From: drainage <drainage@midsussex.gov.uk>
Sent: 26 September 2025 15:08:59 UTC+01:00
To: "Stefan Galyas" <Stefan.Galyas@midsussex.gov.uk>
Cc: "drainage" <drainage@midsussex.gov.uk>
Subject: 2025.09.26 Re: DM/25/2077- 23 Valentine Drive Burgess Hill West Sussex RH15 8UE

We understand the proposed application is to demolish existing conservatory and replace with a single storey rear extension.

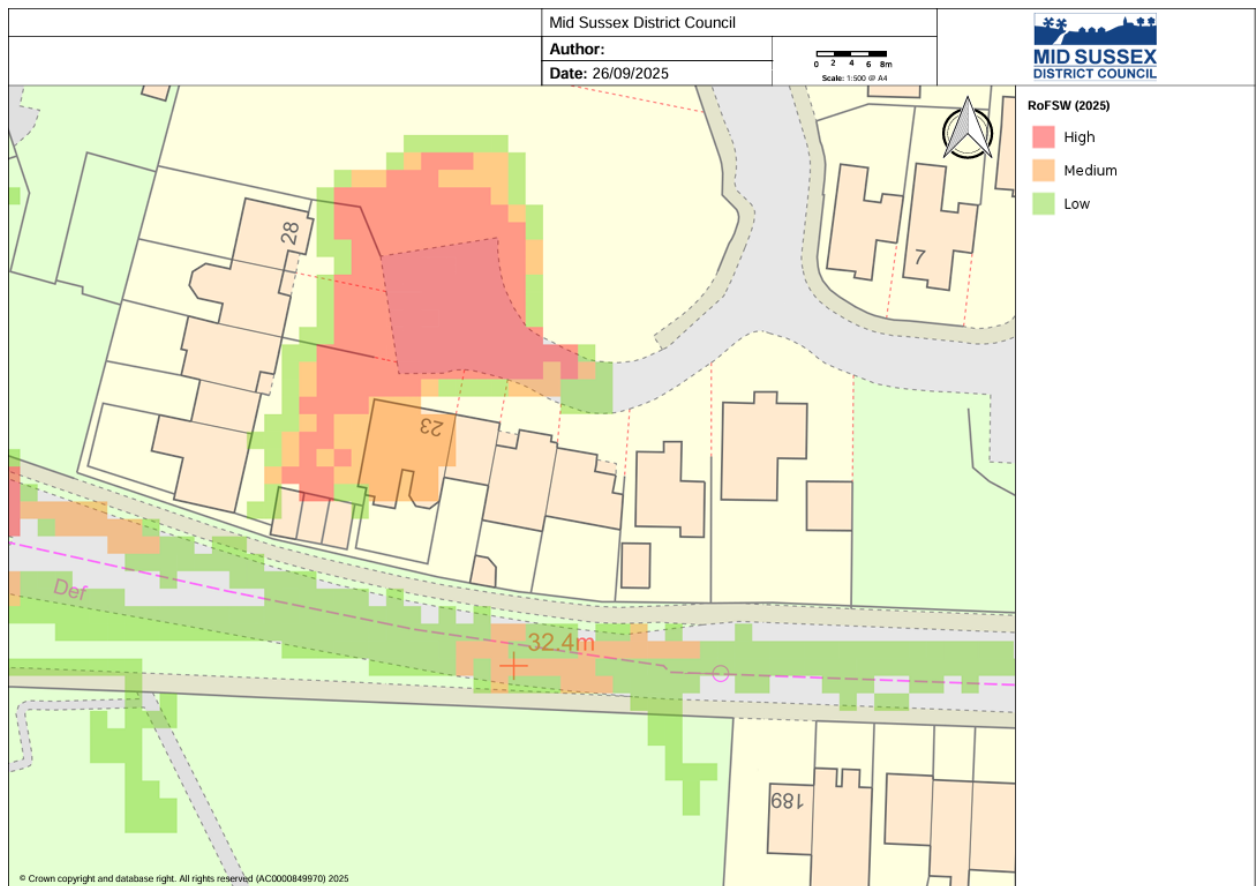
The updated Risk of Flooding from Surface Water mapping released in March 2025 shows the proposed development site is located within an area impacted by High, Medium and Low surface water flood risk. Following the approach set out under the NPPF for assessing fluvial flood risk (flood zones) this area would be considered consistent with Flood Zone 3b, 3a and 2.

As per the Environment Agency standing advice for minor extensions, development within the 1:30 (3b) flood extent is not permissible. In the event that the proposal is outside of this extent, then additional resistance and resilience mitigation will need to be evidenced at this location, as this development is classified as 'more vulnerable'.

In addition to a Flood Risk Assessment, we would advise that the applicant provide an overlay of their proposed block plan on the above screenshot (or equivalent) of the 1:30 flood extent is required at this stage of planning for us to review any encroachment.
